EASA	COMMENT RESPONSE DOCUMENT
	Proposed Equivalent Safety Finding to CS 25.671(c)(2) : Control System (Applicable to Large Aeroplane category)

Commenter 1 : Airbus

See example :

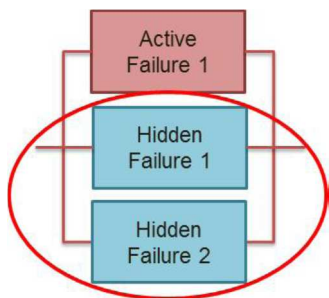
Assessment of any individual failure not Extremely Remote ($\leq 10^{-7}/\text{fh}$) and known to be hidden and not detected at each flight or during daily check, has occurred prior to a given flight.
Hidden Failure 2 is the individual failure :

- $(A1, H1) \leq 10^{-6}/\text{fh (CAT)} / 10^{-4}/\text{fh (HAZ)}$

Proposal is PARTIALLY ACCEPTED - We believe that the proposed wording from Airbus has the same result as the existing Generic ESF, but EASA prefer to keep the existing wording. Airbus could propose to use the above wording for such an ESF on a specific project in the future. The exception to this is that the exception for Latent failures <1E-07 is not acceptable. The criteria is also to be applied to combinations involving an Extremely Remote individual Latent Failure.
